Access Compliance Report

Public Rights-of-Way

(Curb Ramps)

Intersection ID: 30215	Main Street: BRYAN_FURR_DR	Cross Street: SLATER_RD	Location: NE
ADA ID: C8B90D5CB7FD	Ramp Type: Perp	Initial Pass/Fail: Fail	Overall Compliance: No
		Severity Score: 12.5

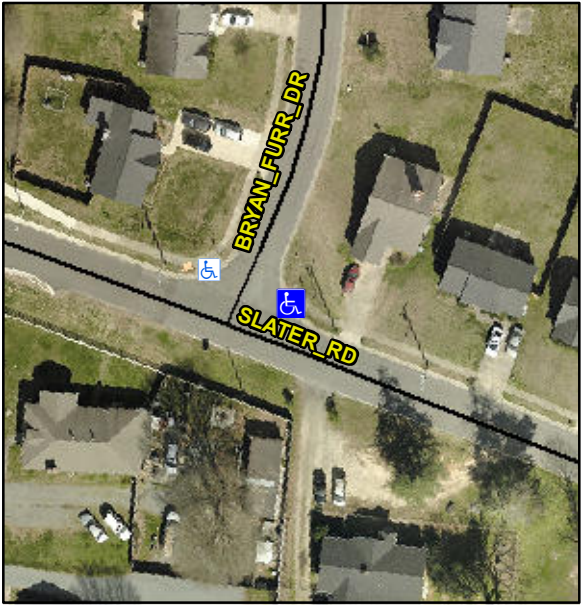
Codes/Mitigation Info/Possible Solution			Field Measurements/Component Compliance		
	Possible Solutions:		Compliance	Description	Data
	Remove & Replace Entire Ramp.		N/A	Ramp Length (in)	48.0
			Yes	Ramp Width (in)	55.0
			N/A	Flare Type LT	N/A
			N/A	Flare Slope LT (%)	N/A
			N/A	Flare Traversable LT?	N/A
			N/A	Landing Length (in)	N/A
			N/A	Landing Width (in)	N/A
			N/A	Landing Slope (%)	N/A
			N/A	Landing X Slope (%)	N/A
			N/A	Landing Curb? (Y/N)	N/A
			N/A	Shared Landing?	N/A
			N/A	Gutter Ponding?	N/A
			N/A	Gutter Lip Ht (in)	N/A
			N/A	Painted X Walk1?	No
				X Walk 1 Direction	To NW
			N/A	X Walk 1 Width (in)	N/A
				X Walk 1 Slope (%)	1.2
				X Walk 1 X Slope (%)	5.2
			N/A	Ramp inside XWalk1?	N/A
<p>Surveyor Notes:</p> <p>N/A</p> <p>PROW/ADA:</p> <p>Not Found, R304.5.3</p>			N/A	Flare Type RT	N/A
			N/A	Flare Slope RT (%)	N/A
			N/A	Flare Traversable RT?	N/A
			N/A	DWS Provided?	N/A
			N/A	DWS Contrast?	N/A

N/A	DWS Length (in)	N/A
			N/A	DWS Full Width?	N/A
			N/A	DWS Offset (in)	N/A
			N/A	Gutter Slope (%)	N/A
			N/A	Gutter X Slope (%)	N/A
			N/A	Painted X Walk2?	N/A
				X Walk 2 Direction	N/A
			N/A	X Walk 2 Width (in)	N/A
				X Walk 2 Slope (%)	N/A
				X Walk 2 X Slope (%)	N/A
			N/A	Ramp inside XWalk2?	N/A
			N/A	Clear Space?	N/A
			N/A	Clear Space to XWalk (in)	N/A
			N/A	Storm Grate/Utility Hazard?	N/A
				Storm Grate/Utility Type	
<p>Total Cost:</p> <p>\$ 1850.00</p>			N/A		N/A
			Yes	Surface Condition? (G/P)	Good
